Review 1

398 Broadway, LLC Preliminary and Final Major Site Plan Application P-24-010 Central Business District (CBD)

398 Broadway
Block 226, Lot 44

January 2, 2025

Front Façade of Building from Broadway

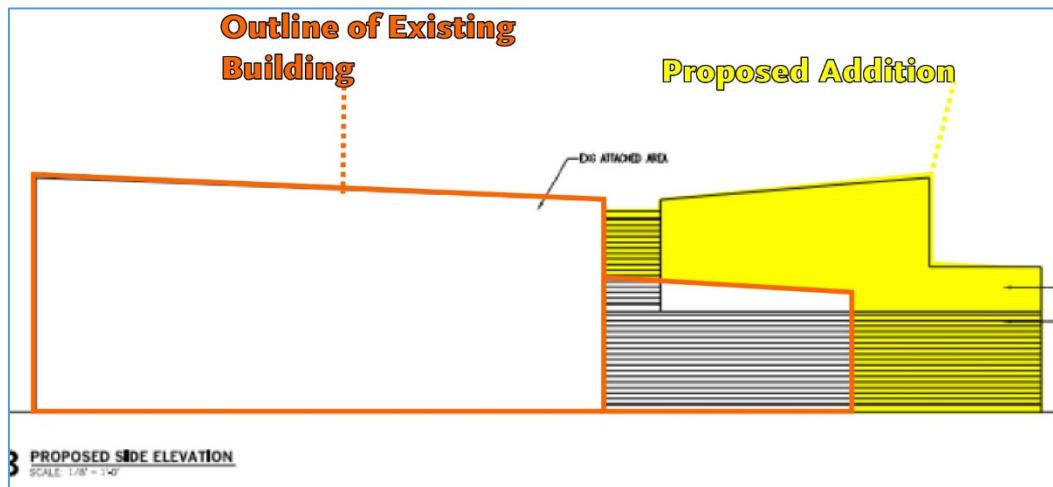
However, if the photograph of the front of the building as it exists is reviewed (preceding page), a refreshing of the second story should be proposed. The siding consists of two different lots of materials, the exterior facing air conditioning unit is unattractive, and the soffit boxed with sheet metal provides no aesthetic relief. With the applicant making this level of investment, this exterior appearance of the second area story on Broadway should also be included in the apartment expansion and renovation plans.
